Docket Number:	09-AFC-05C
Project Title:	Abengoa Mojave Compliance
TN #:	232687
Document Title:	COMP14-06-00 Carbon Adsorption System Improvement
Description:	COMP14-06-00 Carbon Adsorption System Improvement
Filer:	Jose Manuel Bravo Romero
Organization:	Mojave Solar Project
Submitter Role:	Applicant
Submission Date:	4/7/2020 11:52:20 AM
Docketed Date:	4/7/2020

Petition to Amend

COMPLIANCE 14-06-00 Carbon Adsorption System
Improvement

Basis Of Design For Improved Carbon Bed System

(High Pressure System Triplex Carbon Bed, Model 1106 Drawing 1106-B)

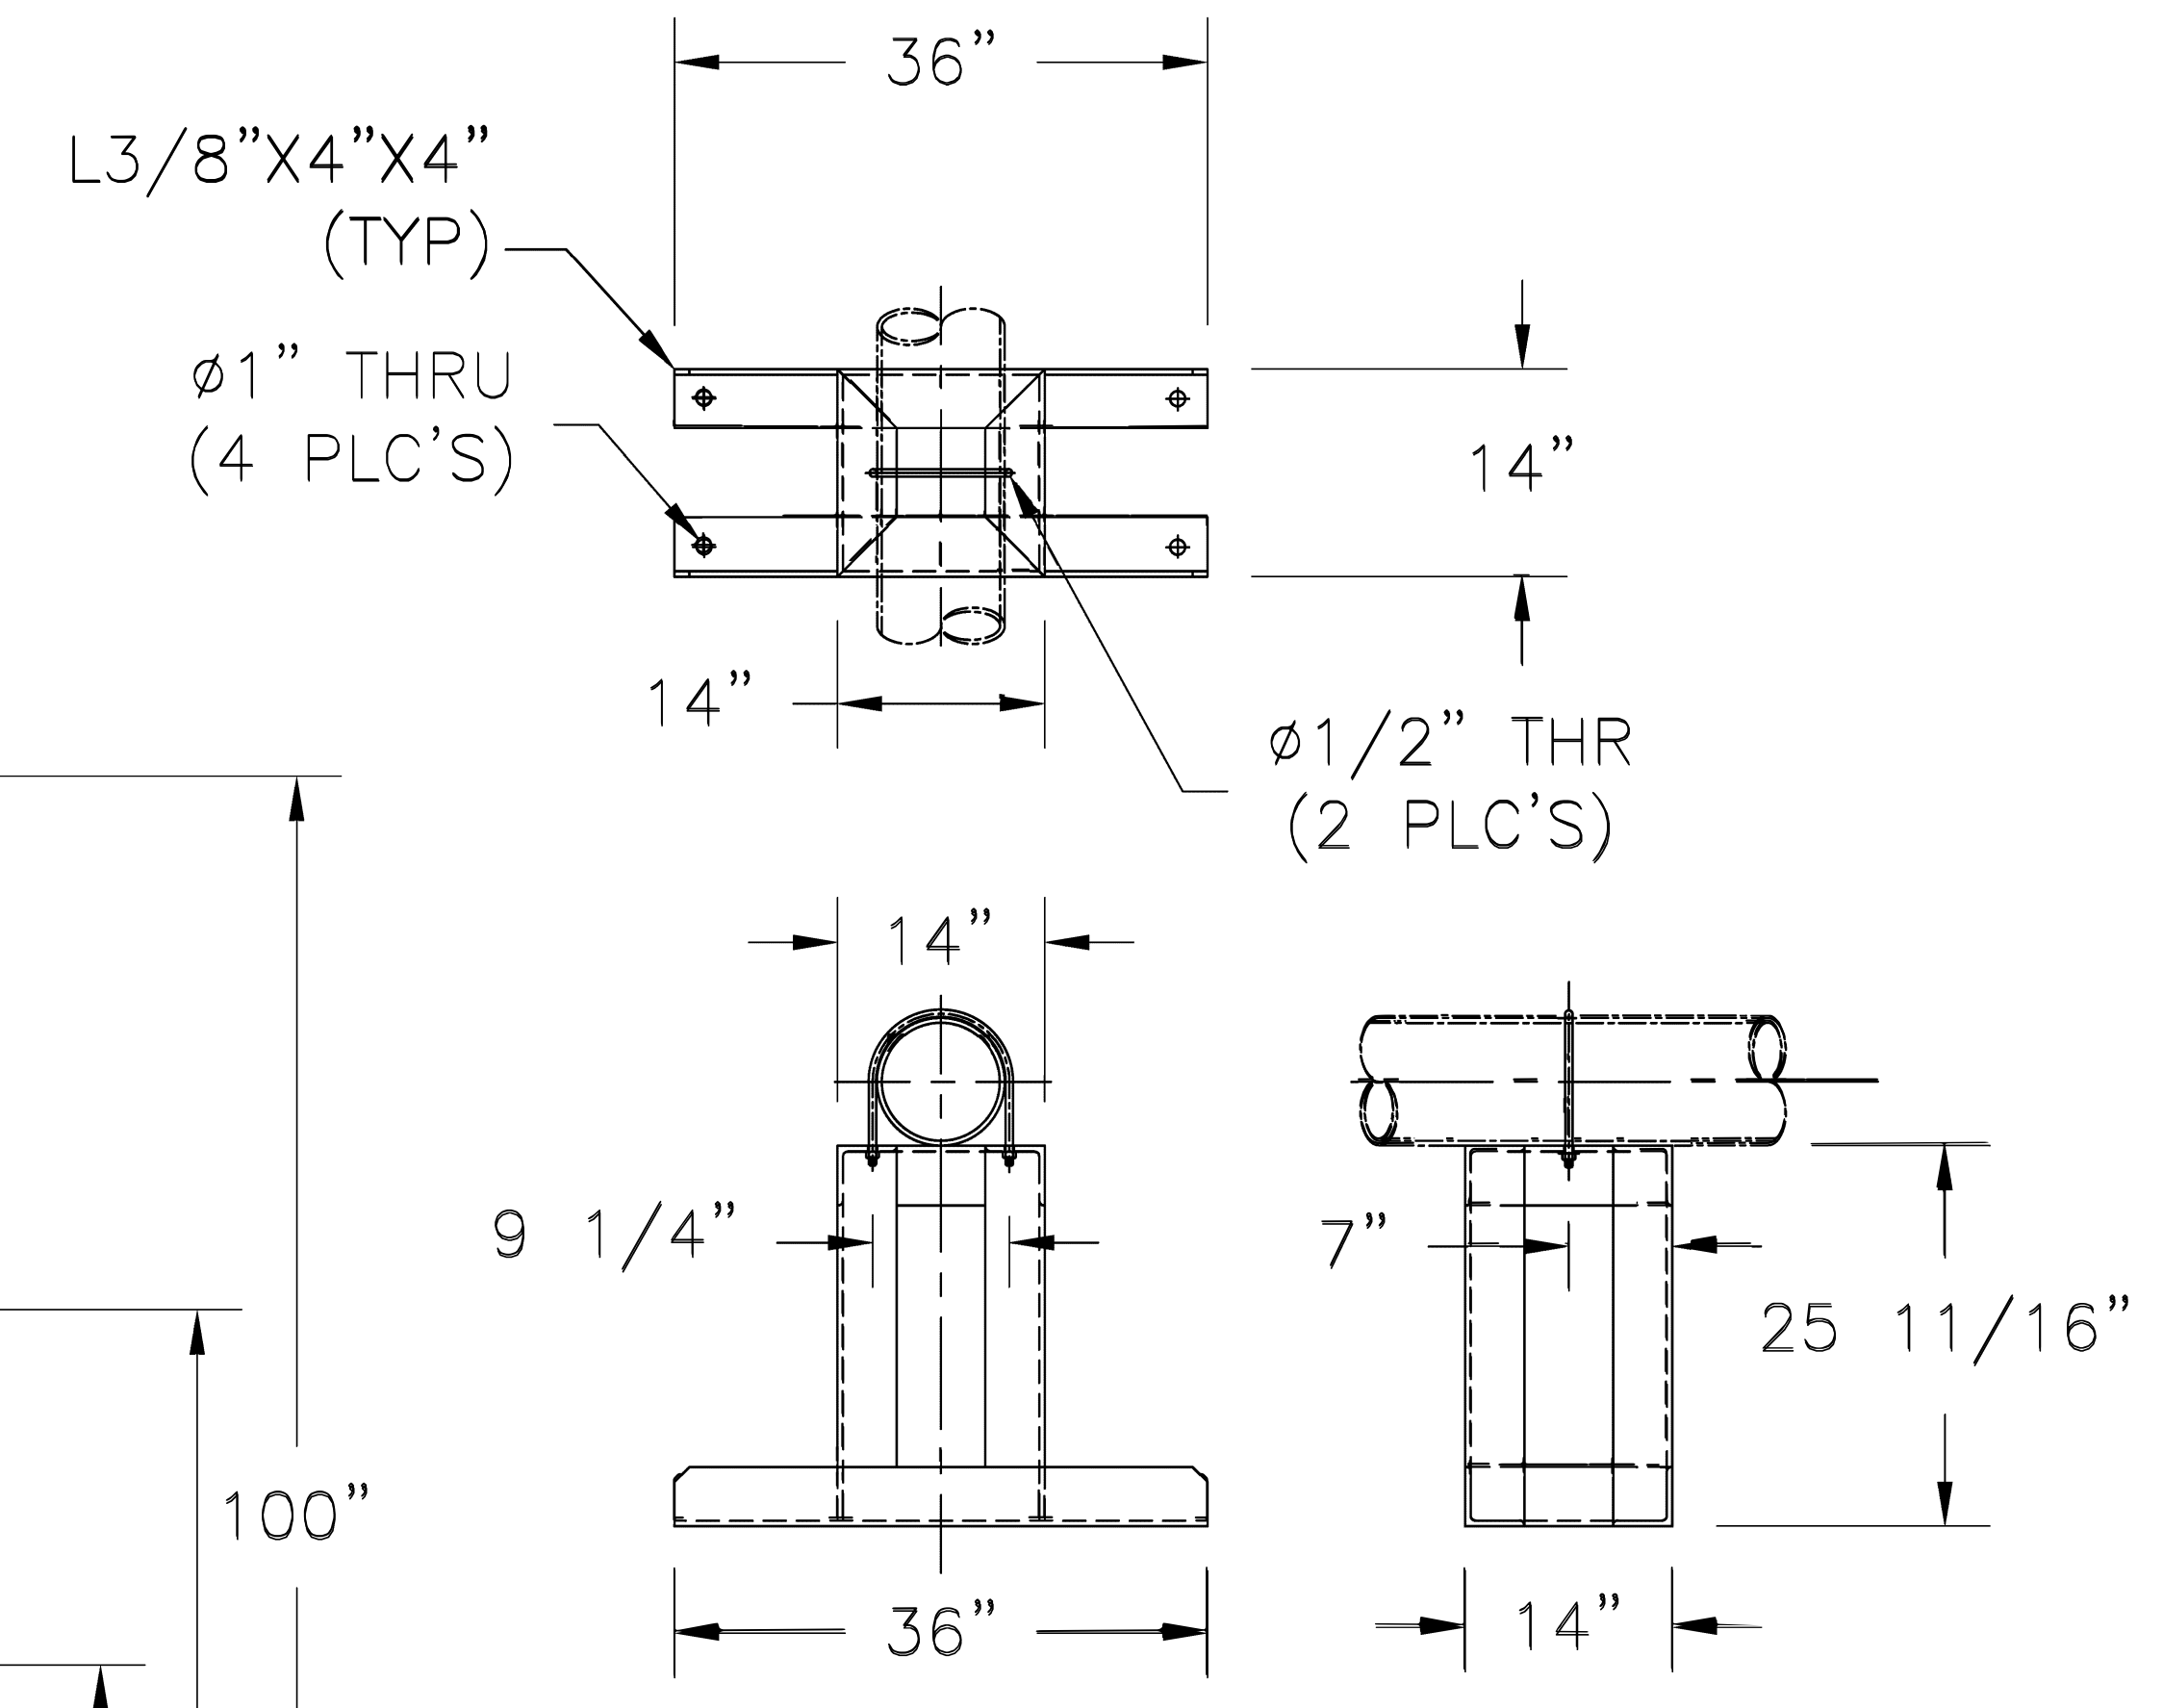
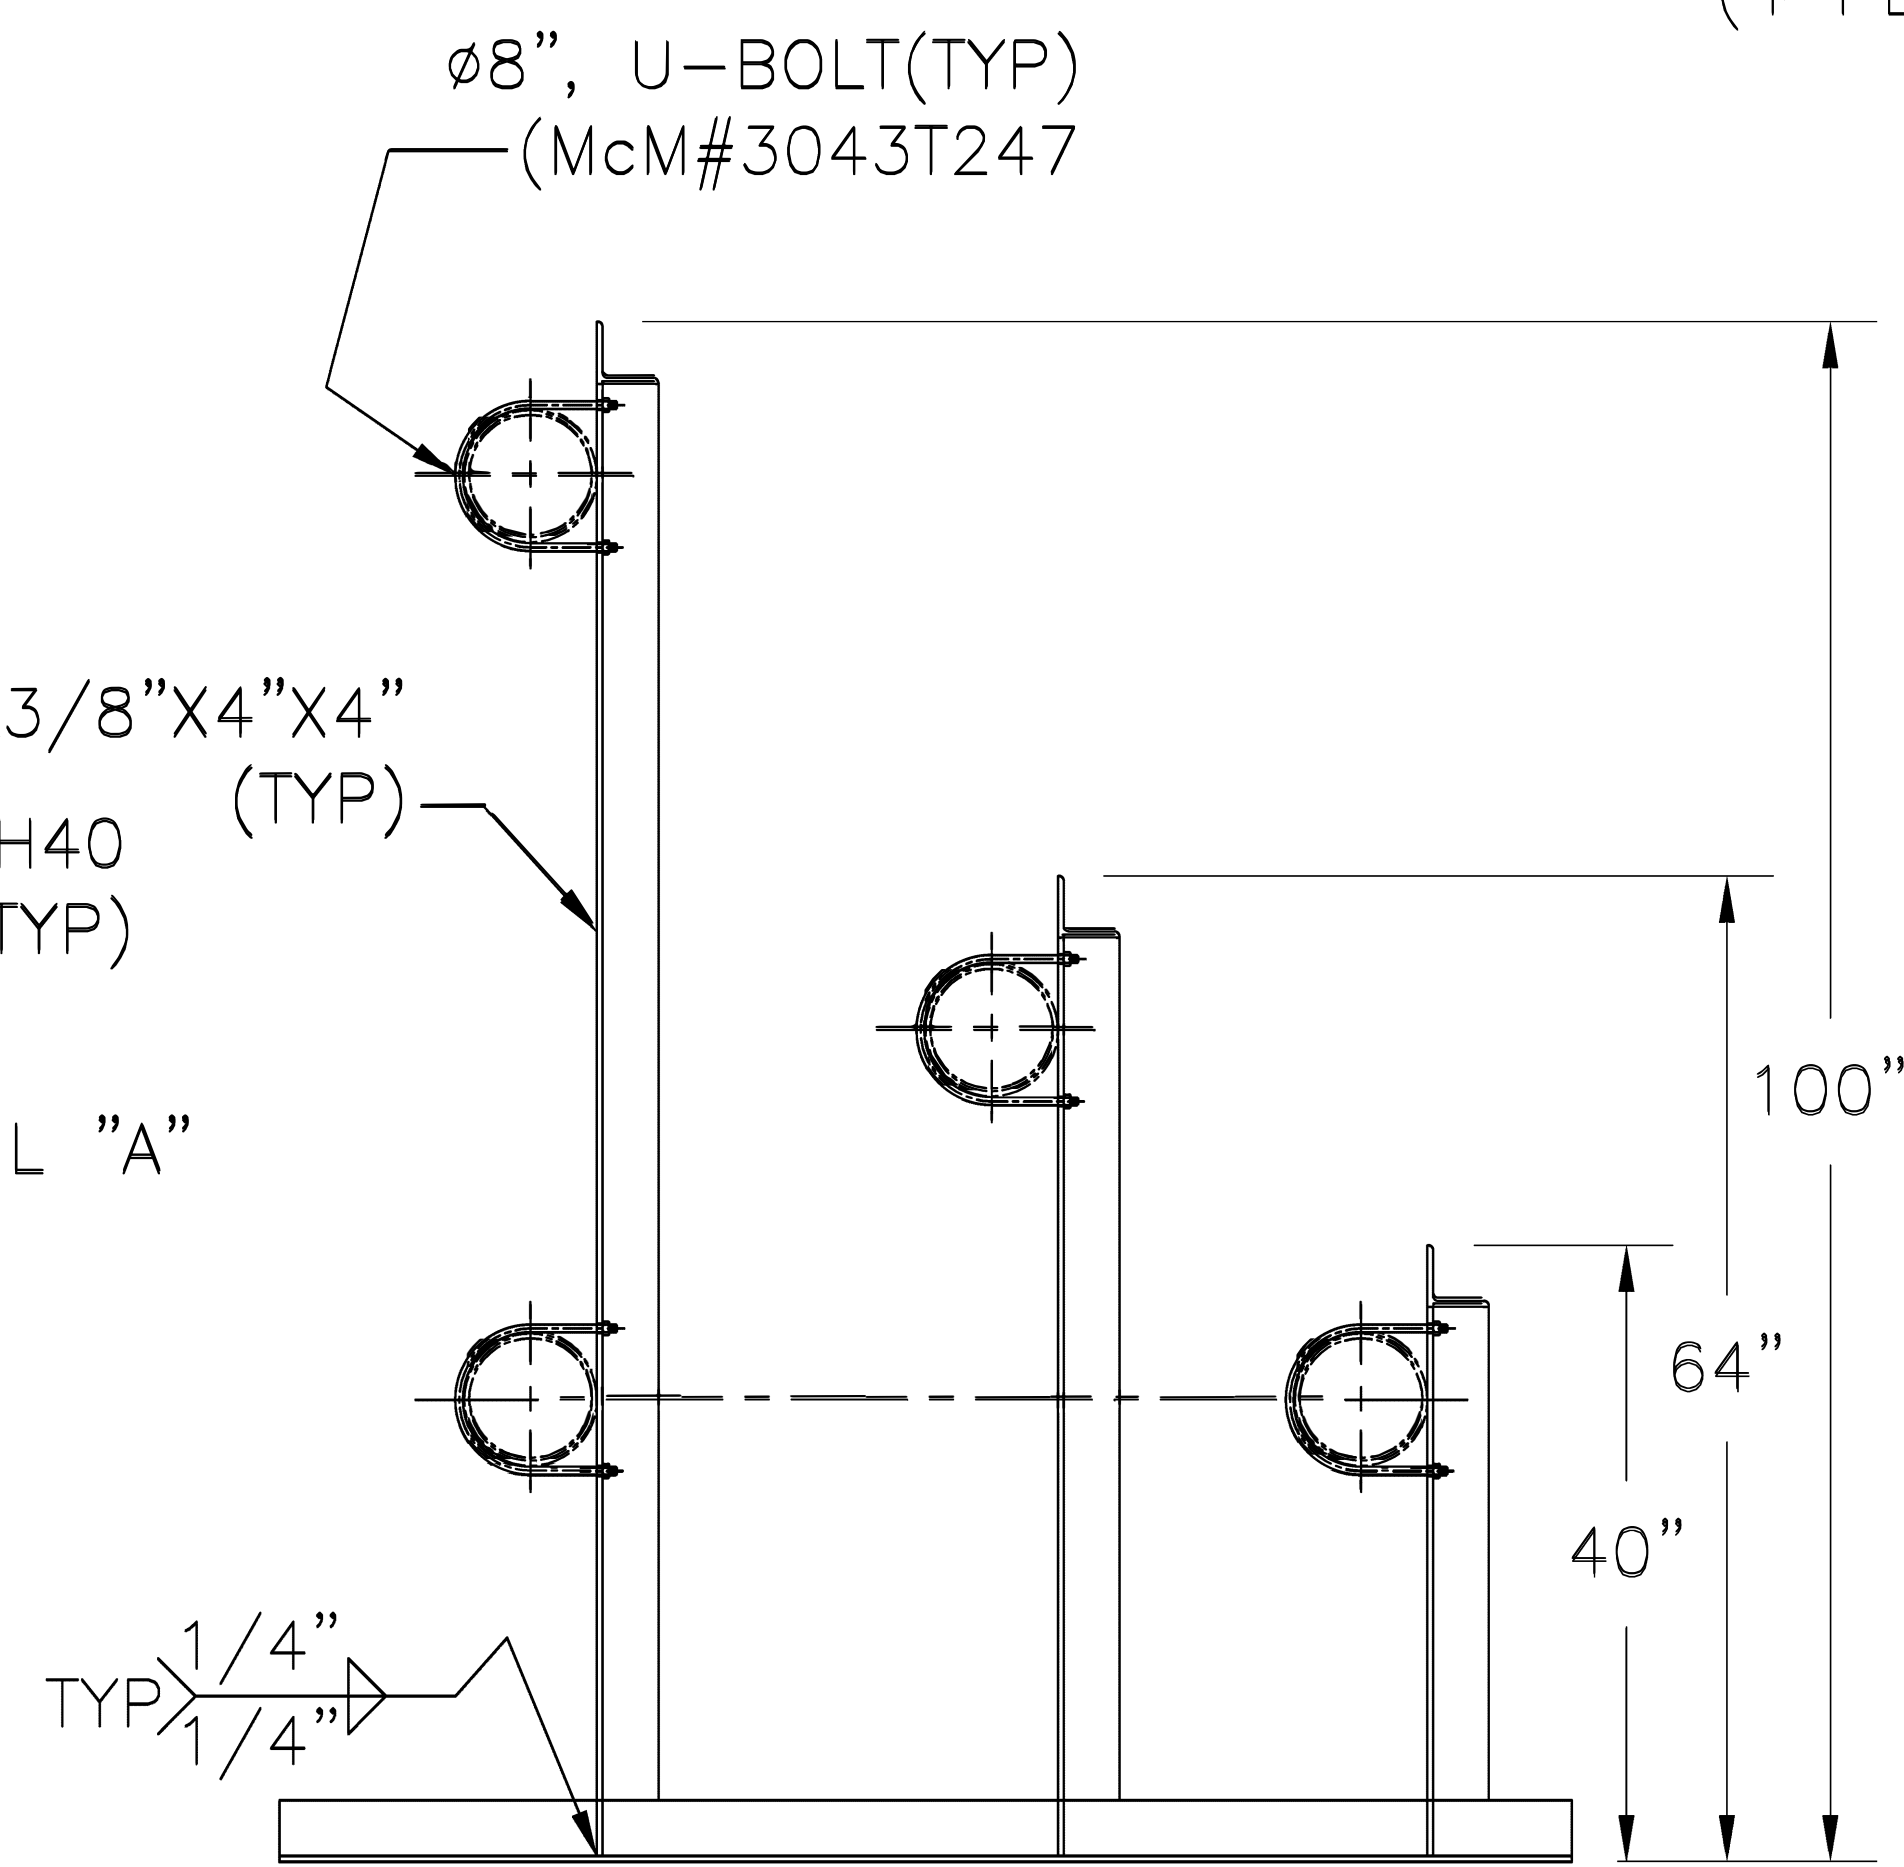
Carbon supply Inc recommends carbon bed system that can provide vertical flow orientation. The proposed canisters will include a flat activated carbon bed support across the entire cross-sectional area as well as a plenum area below this support for effective air distribution across the bed. In order to handle a wide range of flows and VOC concentrations, the systems will include three vessels that can be used one at a time, operated in parallel, or in series. The three canisters will be interconnected using a pipe rack system that allows the vessels to operate in series, lead lag, or single vessel. For the high-pressure system, each carbon bed is designed to contain 3,000 lbs. of activated carbon media. The low-pressure system will also consist of three carbon beds and each will contain 1,000 lbs. of carbon media.
